**Re: Avalon Office Building, Northeast Corner Unser & Tower SW  
Grading & Drainage Plan-Engineer's Stamp dated 12-21-05 (L10-D29)**

**Re: Avalon Office Building, Tower and Unser Blvd., Grading and Drainage Plan (L10-D29)**

**Re: Avalon Office Building, Tower Rd. SW**  
**Grading and Drainage Plan**  
**Engineer's Stamp dated 11-14-05 (L10-D29)**

**Re: Avalon Office Building, Tower and Unser Blvd.,  
Grading and Drainage Plan  
Engineer's Stamp dated 10-13-05 (L10-D29)**

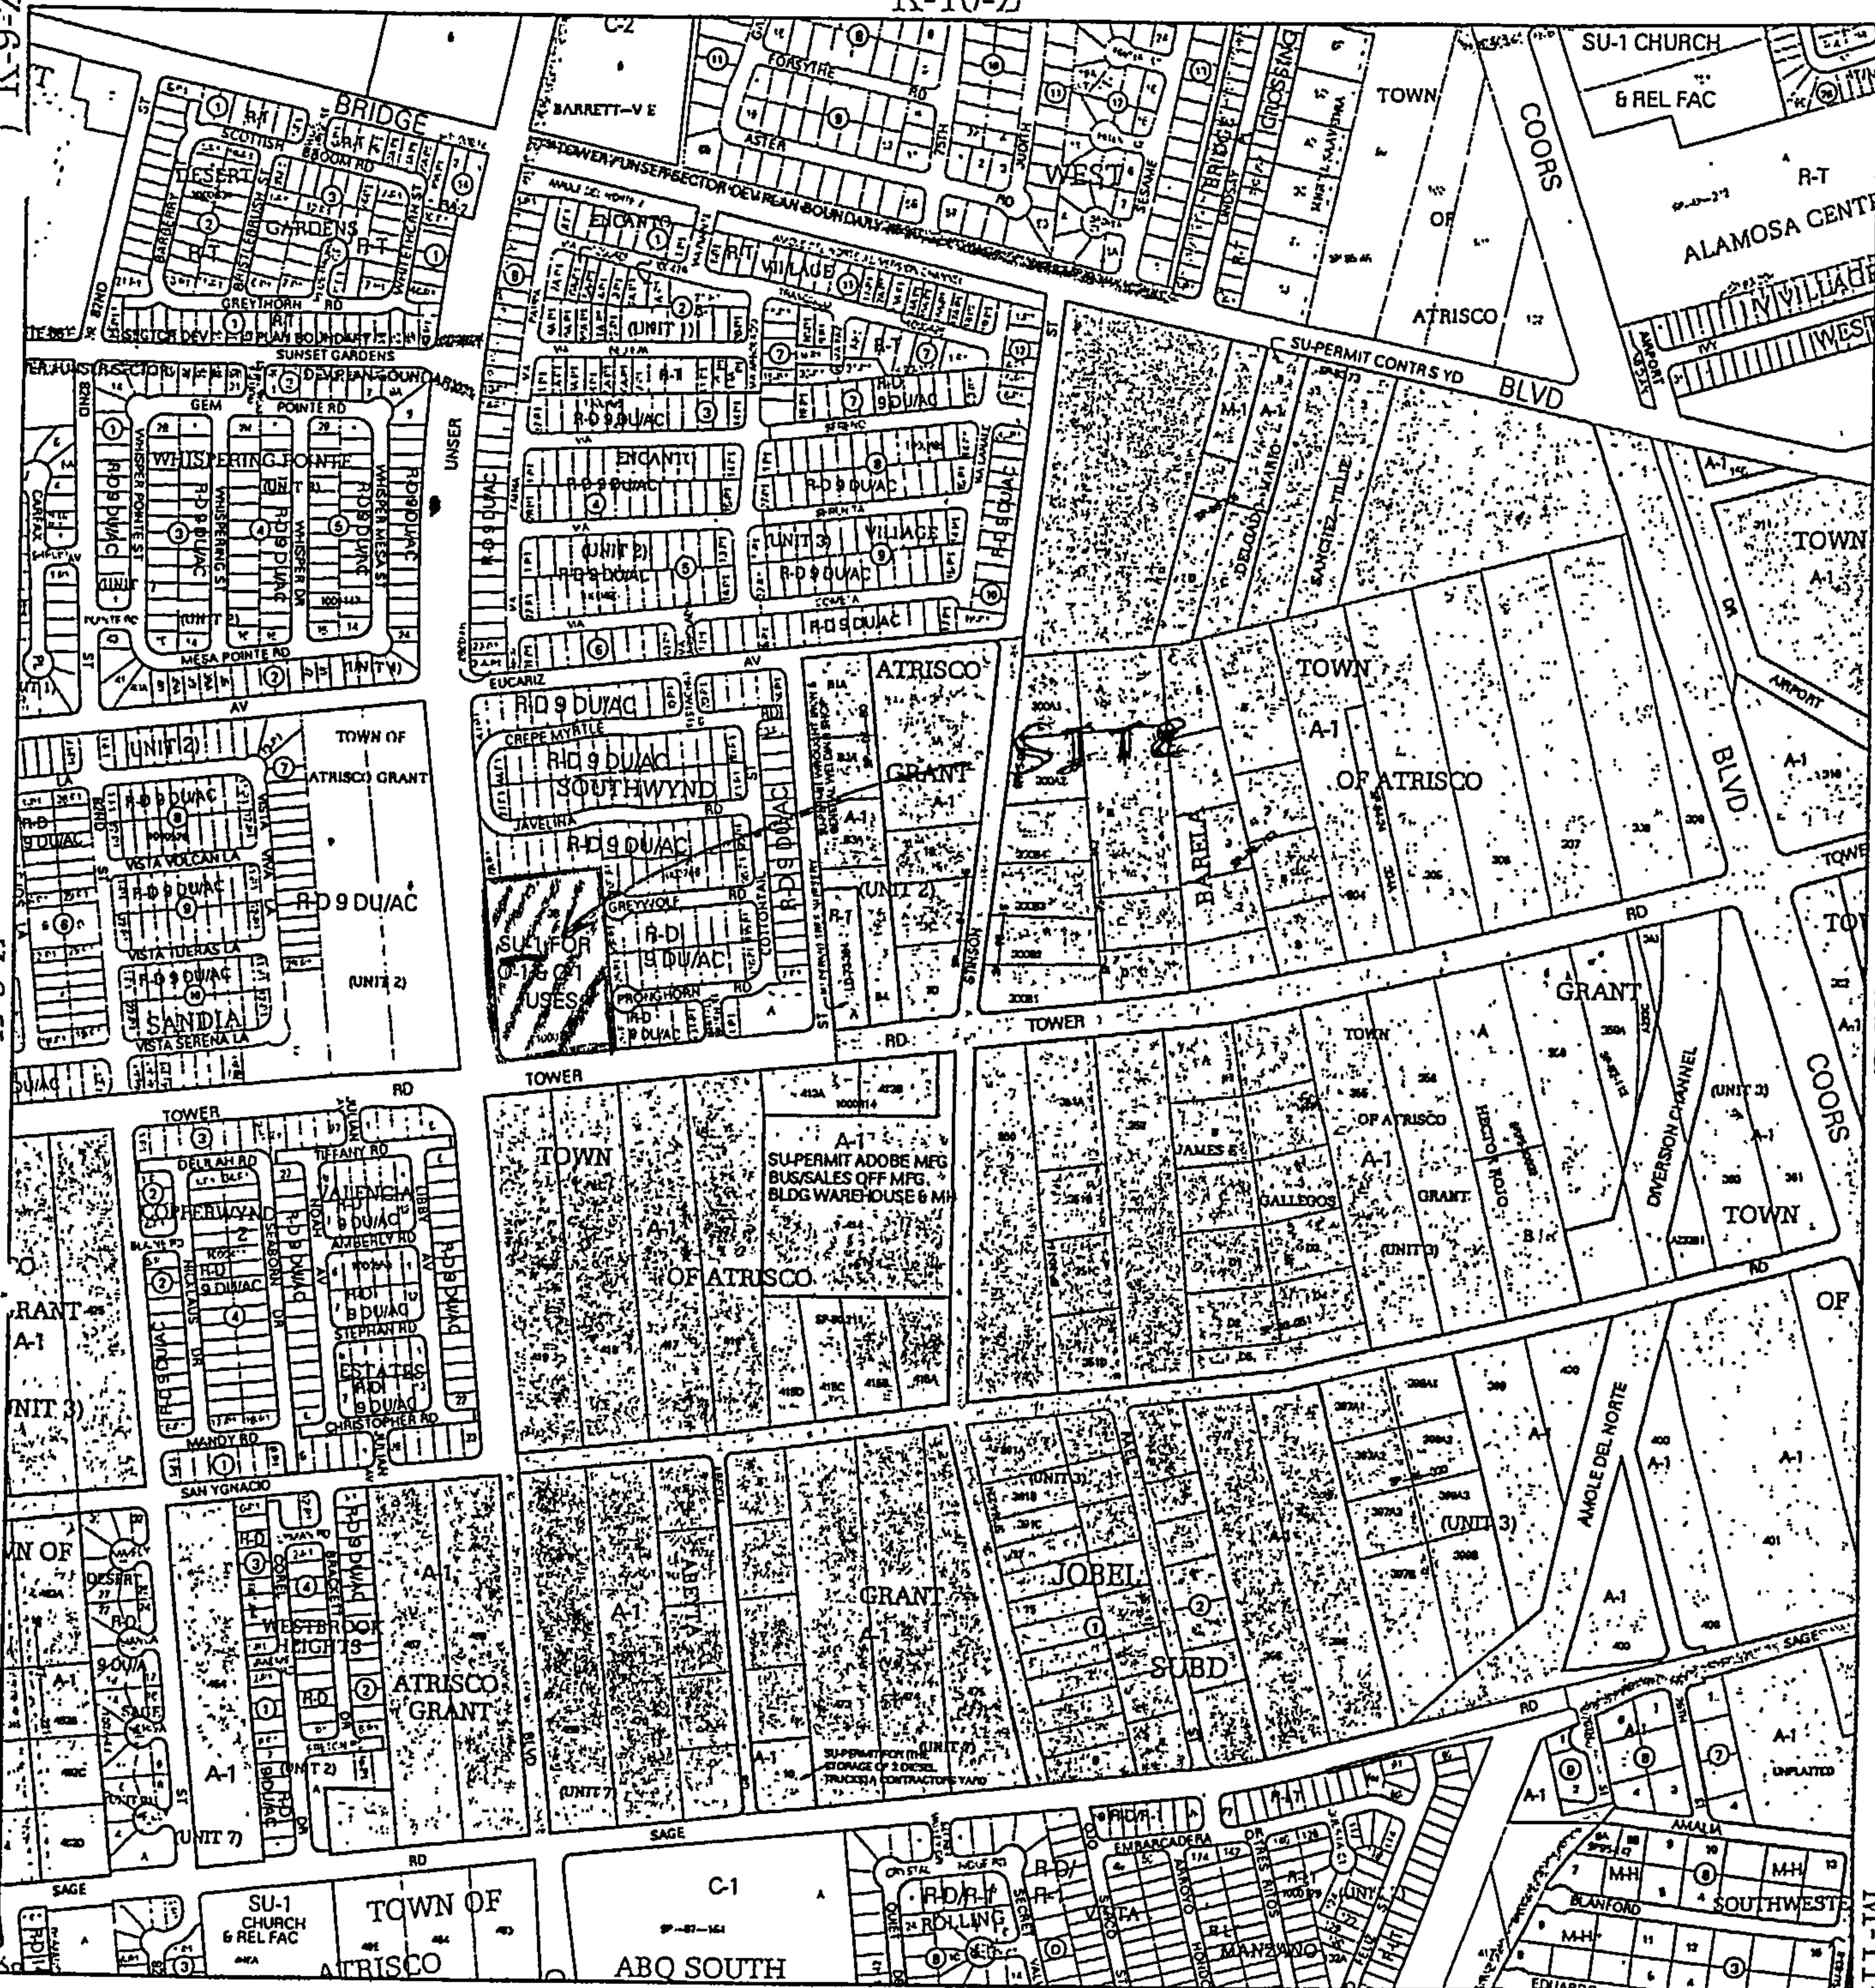
Only 2 Basins

Only 4.48 acres Calculated
